Public Works (1894) Department.

Collector's office at Madura.

Submitting a Report, after
visiting Madras & con-
sulting the Collector on
certain proposals for
utilizing the vacant plot
of ground for the extension
of the Buzur Treasury
room in the Collector's
office at Madras.

Collector's office Building
at Madura.

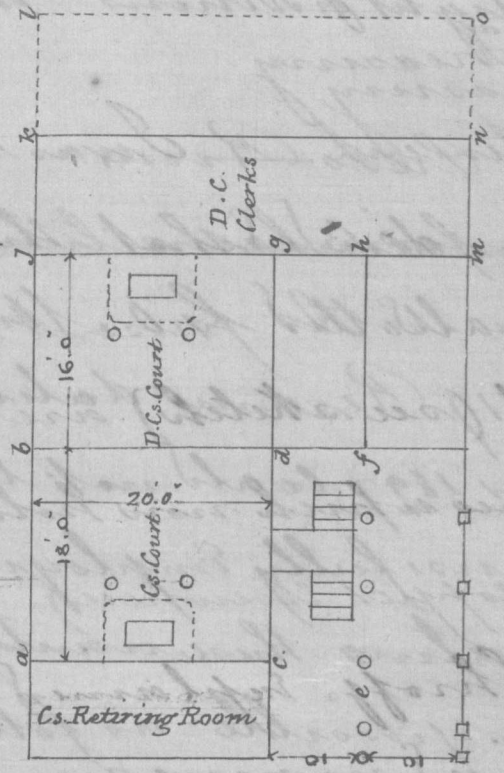
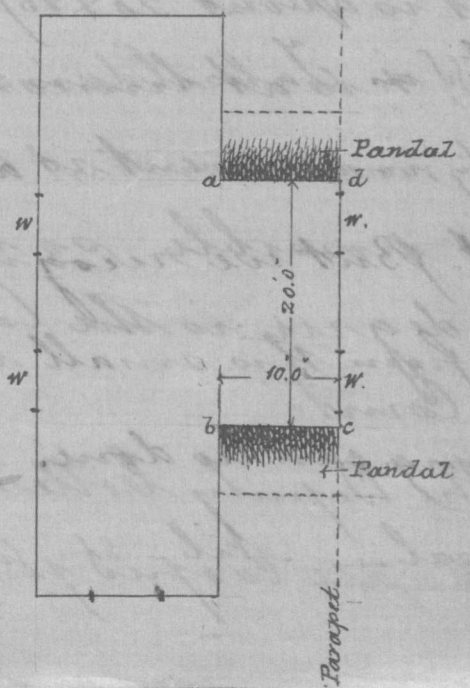
(b) " " Collectors " Statements - The Courts are in just a - positions as shown in sketch, the measurements on which are approximate.

The Deputy Collectors Court is about 20 x 16 is much used, & is at times so full that movement is only just possible: so in, or less degree is the Collectors own Court.

The Deputy Collectors & Clerks are cramped put in

(b) This room is unfit for a Court I do not think it should be extended as it will not really be used in future.

I have told the Asst. Collector to use a room downstairs when available and he could use my own room generally 4 days a week. The present room may amply be used for his Clerk to keep records &c. By extending it to D.C. the way to my Sheristadar's & Clerks' room is blocked. (sigd) J.P.

Remarks - Beyond the Asst. Collector's room the Collectors Sheristadar and about 20 Clerks have a room. There should be a staircase leading from that end to the lower floor, a wooden one would do (Signed) J.P.

Proposal - In walls cd, dg - turn 13' to 14' arches. floor over spaces efcd, d.f.h.g, & partition ef, converting Court rooms ab.cd, & b.d.g.f into a.f.b, & b.f.h.j.

Extend clerks room j.k.m.n to l.o.:-
